Access Compliance Report

Public Rights-of-Way

(Curb Ramps)

Intersection ID: 3127	Main Street: GEMSTONE_CT	Cross Street: MINERAL_RIDGE_WY	Location: E
ADA ID: 902C0460C56A	Ramp Type: Perp	Initial Pass/Fail: Fail	Overall Compliance: No
Severity Score: 36.25			
Codes/Mitigation Info/Possible Solution		Field Measurements/Component Compliance

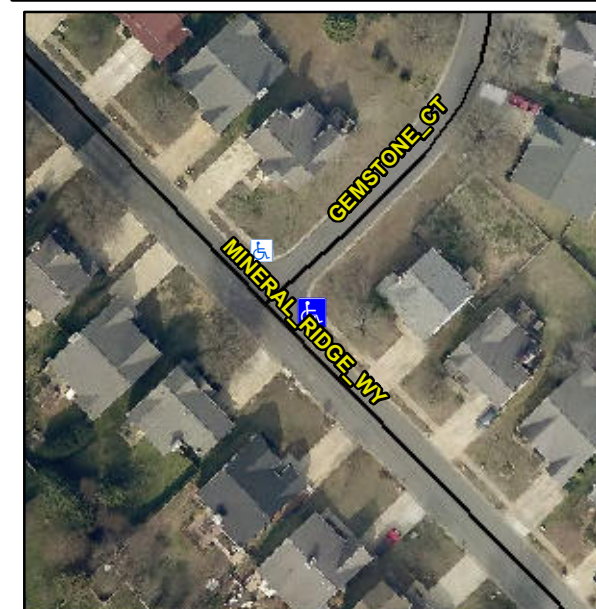
Not Found, R304.5.1, R304.5.3

Compliance	Description	Data	Compliance	Description	Data
N/A	Ramp Length (in)	92.0	Yes	Ramp Slope (%)	5.2
No	Ramp Width (in)	30.5	No	Ramp XSlope (%)	4.1
N/A	Flare Type LT	N/A	N/A	Flare Type RT	N/A
N/A	Flare Slope LT (%)	N/A	N/A	Flare Slope RT (%)	N/A
N/A	Flare Traversable LT?	N/A	N/A	Flare Traversable RT?	N/A
N/A	Landing Length (in)	N/A	N/A	DWS Provided?	N/A
N/A	Landing Width (in)	N/A	N/A	DWS Contrast?	N/A
N/A	Landing Slope (%)	N/A	N/A	DWS Length (in)	N/A
N/A	Landing X Slope (%)	N/A	N/A	DWS Full Width?	N/A
N/A	Landing Curb? (Y/N)	N/A	N/A	DWS Offset (in)	N/A
N/A	Shared Landing?	N/A			
N/A	Gutter Ponding?	N/A	N/A	Gutter Slope (%)	N/A
N/A	Gutter Lip Ht (in)	N/A	N/A	Gutter X Slope (%)	N/A
N/A	Painted X Walk1?	No	N/A	Painted X Walk2?	N/A
	X Walk 1 Direction	To NW		X Walk 2 Direction	N/A
N/A	X Walk 1 Width (in)	N/A	N/A	X Walk 2 Width (in)	N/A
	X Walk 1 Slope (%)	2.1		X Walk 2 Slope (%)	N/A
	X Walk 1 X Slope (%)	2.5		X Walk 2 X Slope (%)	N/A

Remove & Replace Entire Ramp.
